### **Sydney Metro and Martin Place Station Precinct - Peer Review**

Further to our recent conversations and meeting of 12 March, I provide a peer review of the recently updated View Impact Analysis report (March 2018) prepared by Tzannes Associates, supporting the Sydney Metro and Martin Place Station Precinct planning proposal, as submitted by Ethos Urban on behalf of Macquarie Corporate Holdings Pty Ltd (hereafter the Proposal). I confirm that in addition to the above I have also reviewed as relevant to the issue of visual impact the following documents:

Excerpt from View Impact Analysis Report (January 2018) prepared by Tzannes Associates – View ‘A’  
Photomontages

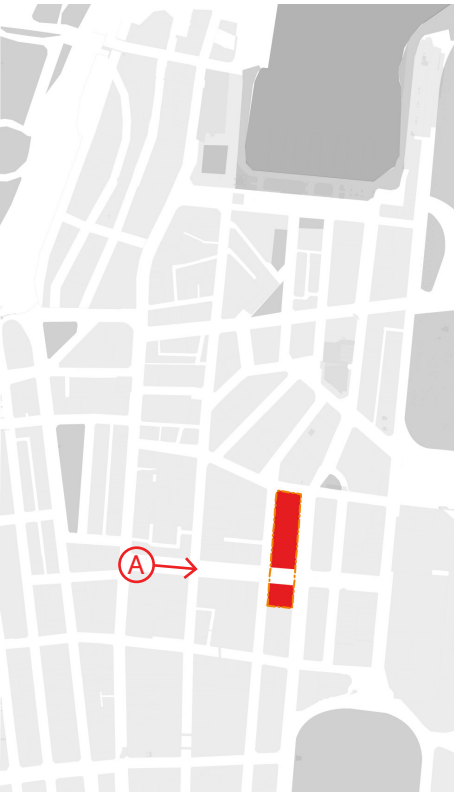
The existing view of the southern building edge provides an exemplary example of this building height control, with an intact sandstone street wall, affected by only minor visual incursions of modern built form which is setback some 25m or more from the street wall of both 1 Martin Place and 5 Martin Place. The tower of the MLC Centre is setback some 75m and unseen from this location (refer Attachment B).

More than half way up Martin Place, a small portion of the taller existing building at the South Site can be seen protruding beyond the street wall of 5 Martin Place (partially obscured by vegetation). However, it does not project above the Pitt Street street wall, retaining the sharp roofline edge with the sky, and helping to retain the strong perspective lines of the street wall façades converging towards an unseen vanishing point. This retention of boundary definition between the street wall and the sky creates a distinct, generous widening of visual access to the sky along the southern edge of Martin Place, framed by the street wall and GPO clock tower (refer Attachment B - 'View A' / 'Existing'). By comparison, the new building on the northern corner of Pitt Street (20 Martin Place – ANZ Building) projects well above the street wall, creating a visually contrasting 'high wall' that terminates the converging perspective of the historic buildings, and breaks the low sandstone street wall. The view of the sky is notably reduced along this edge.

- The introduction of a visually prominent tall tower element of substantial bulk within the context of the southern street wall, which importantly breaks the open skyline view of the street wall, seen from this location as a constricted 'canyon' form.
- The tower appears to be very close to the podium, causing it to be perceived as part of a new, uncharacteristic section of 'high' street wall, which visually 'pairs' with the new 20 Martin Place glass tower wall, re-framing the horizontal and vertical proportions of the place. The sense of the openness of the Martin Place corridor would be reduced. This effect comprises an important visual consideration when determining a setback distance for the proposed tower.

- The View Impact Analysis report states that articulation of the tower and podium will facilitate definition of the streetscape is maintained and enhanced. However, from this viewing point much of the articulation may not be visible during the warmer months (i.e. when these deciduous street trees are in leaf).

- The tower wall facing onto Martin Place, while still substantial, appears to sit just behind the street wall of 5 Martin Place.
- There is clearer separation between the podium and the tower, although the tower still appears to visually relate with the 5 Martin Place street wall.
- The bulk and scale of the tower is still commensurate with that of the proposed 8m setback tower.

- The tower wall sits noticeably behind the end of the 5 Martin Place street wall which assists in defining separation with the podium street wall.
- The bulk and scale of the tower is clearly reduced over that for the 8m setback, and still visually 'square' in proportions.
- The constrained 'volume' of the sky view between the ANZ tower and the proposed tower is noticeably improved over that for the proposed tower.

- The tower is visually setback close to midway through the street wall of 5 Martin Place and is more visually subservient in terms of bulk and scale, with the height of the envelope noticeably reduced compared with that of the proposed 8m setback.
- The volume of the sky view between the ANZ tower and proposed building envelope is noticeably improved over that for the 8m setback.
- The tower is noticeably more slender than for the 8m setback. However, the depth of the tower appears disproportionately slender

This view is distinguished from the other two views in that it is the only view in which the whole of the tower can be seen, i.e. both the front of the tower and back edge, i.e. the full tower form is seen in silhouette against the skyline. For the other two views, the back of the tower is unseen. The 15m setback provides the greatest volume of sky view of the three alternative setback options and is prominently setback from the podium edge, but the visual mass / proportions of the tower envelope are potentially not as visually complimentary with that of the 5 Martin Place building as for the 12m setback tower. Therefore, on balance I would suggest the 12m setback is the least visually intrusive of the three setback options in this instance.

- For View 'A', the least visually intrusive setback distance is considered to be 12m. This view is distinguished from the other two views in that it is the only one in which the whole of the tower can be seen, i.e. both the front and back of the tower, with the full tower form seen in silhouette against the skyline. For the other two views, the back of the tower is unseen. For this view, the visual mass and proportions of the slimmer tower with the 15m setback are considered on balance to be less visually complimentary with the visual mass and proportions of the 5 Martin Place building than those of the 12m setback tower.

Excerpt from View Impact Analysis Report (January 2018) prepared by Tzannes Associates – View 'B'  
Photomontages

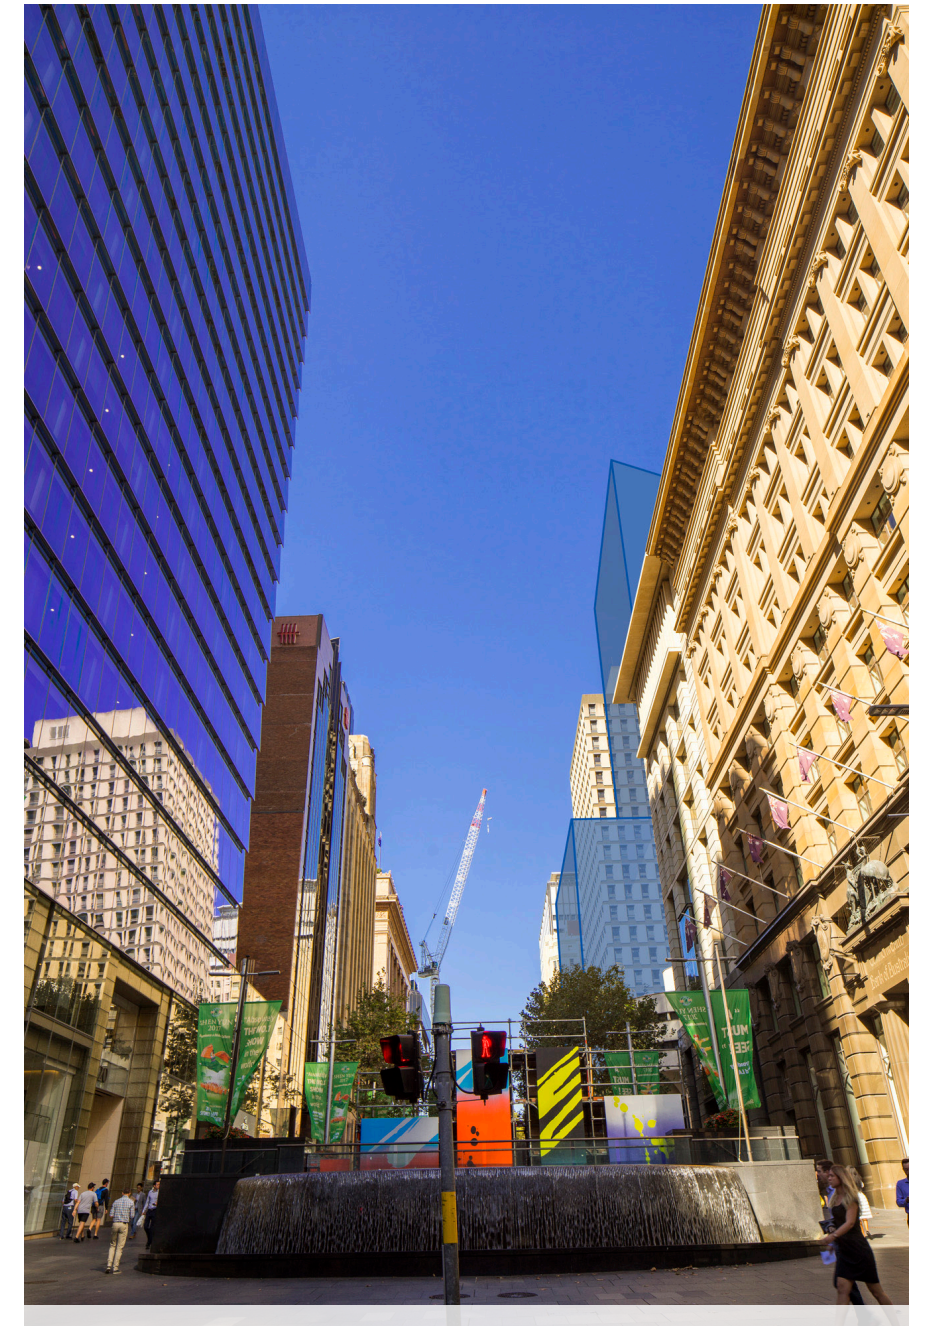
- The podium envelope is set well above the height of 50 Martin Place opposite (Note: The Proposal states that the proposed podium will closely reflect the height and form of the 50 Martin Place façade).

- The tower envelope projects well above the existing street wall height of between about 50m to 80m in height. As such, it comprises a new and uncharacteristic tall tower element, set closely behind a podium street wall edge. This closely stepped setback effect is out of character with all of the street wall buildings seen in this view, including the future 60 Martin Place tower.

- The tower breaks the broadly regular line of the southern street wall as seen from the street, projecting well above 5 Martin Place street wall, unlike the existing South Site building which barely projects above the building when seen from this location.

- The visual mass of the seen part of the building projecting above the 5 Martin Place street wall could potentially be reduced if the top of the building were flat, level with the sun access plane edge.

- Given the proximity of the viewer to the building, the connection between the podium and the tower would be visually prominent from this location, and as such proposed articulation of this interface would assist with defining clear separation between the tower and the podium through the principles set-out in the Urban Design Guidelines.

The visual effects of the tower envelope from this setback are similar to those for the 8m setback (refer Attachment C).

The 12m setback brings the north face of the tower broadly in line with the face of the 5 Martin Place street wall when seen from this location (refer Attachment C). This gives a sense of visual connection with the 5 Martin Place street wall, which provides an element of visual coherence to the tower setback distance.

The 15m setback brings the north face of the tower partially behind the 5 Martin Place street wall when seen from this location, and the extending cornice of the 5 Martin Place street wall seen to project almost fully across the tower face. These factors noticeably reduce the visual prominence of the tower (refer Attachment C). The visual mass and prominence of that part of the tower seen projecting above the 5 Martin Place street wall is significantly reduced over that seen with the 8m setback, and noticeably reduced over the 12m setback.

The setback between the podium edge and tower envelope is most clearly defined for the 15m setback. Further, the 15 metre setback noticeably reduces visibility of the tower wall, helping to reduce the visual prominence of the tower. The loss of sky view as seen from this location is proportionally relatively minor for all setbacks, e.g. when compared with View A. On balance I would suggest the 15m setback is the least visually intrusive of the three setback options. However, I would also consider the 12m setback to be an acceptable option.

- For View 'B', the least visually intrusive tower is considered to be that with the 15m setback, due primarily to: the setback between the podium edge and tower envelope being the most clearly defined of the three alternatives; and that it noticeably reduces visibility of the tower wall, helping to reduce the visual prominence of the tower.

Excerpt from View Impact Analysis Report (January 2018) prepared by Tzannes Associates – View ‘C’  
Photomontages

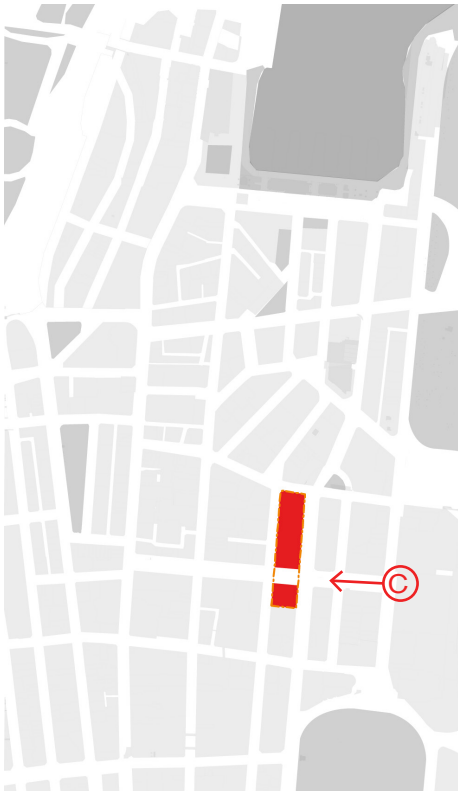
- The podium envelope is set well above the height of 50 Martin Place opposite (Note: The Proposal states that the proposed podium will closely reflect the height and form of the 50 Martin Place façade).

- The removal of the existing building on the South Site opens up a small part of the sky view above the podium when seen from this location (similar for all setbacks).

- The tower envelope projects well above the existing street wall height of between some 50m to 80m in height. As such, it comprises a new and uncharacteristic tall tower element along the southern street wall of Martin Place (but not the northern street wall given the 60 Martin Place tower currently under construction). This effect is not as pronounced as for View A and View B given the adjacent visually prominent, well setback towers within the MLC Centre and at 52 Martin Place.

- The tower envelope is set visually closely behind a podium street wall edge, such that it is seen slightly projecting beyond the street wall of the former APA building (SHR listing), including the angled corner which comprises a visually integral part of the street wall edge. The full building outline of this building is set against the backdrop of the tower and podium.

- The tower envelope is seen as having a similar mass to that of the former APA building.

- The junction between the tower and the podium is barely perceptible from this location, with the tower visually reading as part of the street wall.
- The volumetric openness of the sky view is noticeably reduced and constrained.

- The tower is only marginally further set back. It no longer projects beyond the street wall of the former APA building. The outline of the upper detailed section of the building is still set against the backdrop of the tower and podium rather than being seen in silhouette against the skyline, a key characteristic of building views along the southern street wall.
- The tower envelope is still seen as having a similar mass to the former APA building, and effectively appears to be part of the street wall.
- The tower envelope is still seen as having a similar mass to that of the former APA building.
- The junction between the tower and the podium is not visible from this location, with the tower visually reading as a part of the street wall (notwithstanding the setback).
- The volumetric openness of the sky view is noticeably reduced and constrained.

- The tower is only marginally further set back, although it no longer projects beyond the street wall of the former APA building, and now aligns with the central parapet of the building. This causes the setback of the tower to be noticeably more pronounced than for the 10m setback.
- The outline of the upper detailed section of the building is still set against the backdrop of the tower, rather than being seen in silhouette against the skyline, which is a key characteristic of the existing view.
- The tower envelope is still seen as having a similar mass to the former APA building, although the setback behind the main façade causes the proportions of the tower to appear more visually subservient to those of the APA building.
- The volumetric openness of the sky view is noticeably increased over that of the 8m setback.

- The tower is now seen to be considerably setback behind the former APA building street wall (at the mid-point of the APA building façade), but still presents as having substantial mass similar to that of the former APA building.
- The tower is still seen to be projecting forward of the angled corner of the street wall but is substantially setback from the street wall.

The proportions of the 15m setback tower appear to be visually complimentary with those of the former APA building and provide the most visually definitive setback of the three alternative options. On balance I would consider this option to be the least visually intrusive of the four setbacks assessed. However, I would also consider the 12m setback to be an acceptable option.

- For View 'C', the least visually intrusive setback distance is considered to be 15m given: the proportions of the 15m setback tower appear to be visually complimentary with those of the former APA building; and they provide the most visually definitive setback of the three alternative options. However, the 12m setback is also considered to be an acceptable outcome in that the tower no longer projects beyond the street wall of the former APA building, and the proportions of the tower relative to the former APA building are seen to be complimentary.
